## Product Change Notification / ASER-06ZMCM207

CCB 4630 Initial Notice: Qualification of STA as an additional assembly site for selected LAN9303 device family available in 56L VQFN (8x8x0.9mm) package.

# **CCB 4630**

### **PCN #: ASER-06ZMCM207**

# Lead frame Comparison

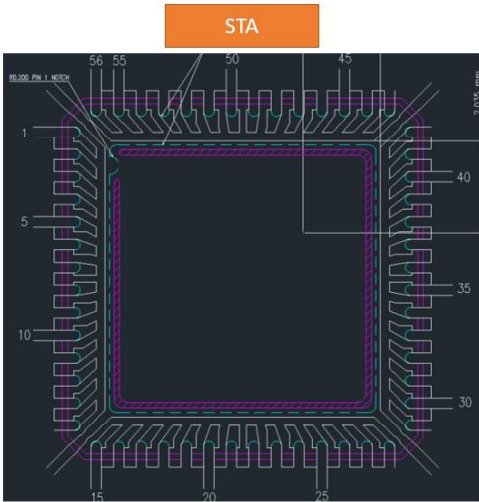
Pre Change	Post Change	
Assembly Site	ASE Inc. (ASE)	ASE Inc. (ASE)	STATS Chippac Ltd. (STA)
Wire material	PdCu	PdCu	CuPdAu
Die attach material	EN-4900F	EN-4900F	8290

<b>Molding compound material</b>	G631B	G631B	G700E
<b>Lead frame material</b>	C194	C194	C194
<b>Lead frame lead lock</b>	No	No	Yes
	See Pre and Post Change Summary for comparison.		
<b>Lead frame paddle size</b>	240X240 mils	240X240 mils	236X236 mils
